Access Compliance Report

Public Rights-of-Way

Intersection ID: 7207	Main Street: HOPE_VALLEY_LN	Cross Street: KINGVILLE_DR	Location:	E
ADA ID: FF9475F2689F	Ramp Type: Perp	Initial Pass/Fail: Fail	Overall Compliance: No	Severity Score: 50

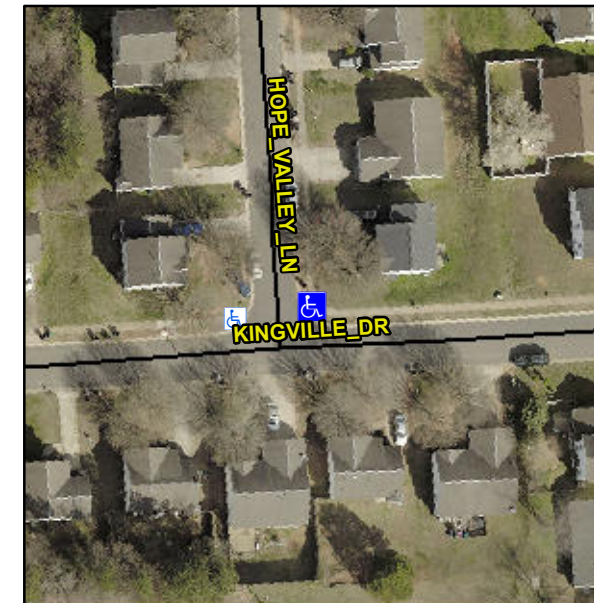
Not Found, R304.2.2, R304.5.3

Compliance	Description	Data	Compliance	Description	Data
N/A	Ramp Length (in)	50.5	No	Ramp Slope (%)	14.0
Yes	Ramp Width (in)	60.0	No	Ramp XSlope (%)	8.4
N/A	Flare Type LT	N/A	N/A	Flare Type RT	N/A
N/A	Flare Slope LT (%)	N/A	N/A	Flare Slope RT (%)	N/A
N/A	Flare Traversable LT?	N/A	N/A	Flare Traversable RT?	N/A
N/A	Landing Length (in)	N/A	N/A	DWS Provided?	N/A
N/A	Landing Width (in)	N/A	N/A	DWS Contrast?	N/A
N/A	Landing Slope (%)	N/A	N/A	DWS Length (in)	N/A
N/A	Landing X Slope (%)	N/A	N/A	DWS Full Width?	N/A
N/A	Landing Curb? (Y/N)	N/A	N/A	DWS Offset (in)	N/A
N/A	Shared Landing?	N/A			
N/A	Gutter Ponding?	N/A	N/A	Gutter Slope (%)	N/A
N/A	Gutter Lip Ht (in)	N/A	N/A	Gutter X Slope (%)	N/A
N/A	Painted X Walk1?	No	N/A	Painted X Walk2?	N/A
	X Walk 1 Direction	To W		X Walk 2 Direction	N/A
N/A	X Walk 1 Width (in)	N/A	N/A	X Walk 2 Width (in)	N/A
	X Walk 1 Slope (%)	2.4		X Walk 2 Slope (%)	N/A
	X Walk 1 X Slope (%)	7.5		X Walk 2 X Slope (%)	N/A

Remove & Replace Entire Ramp.
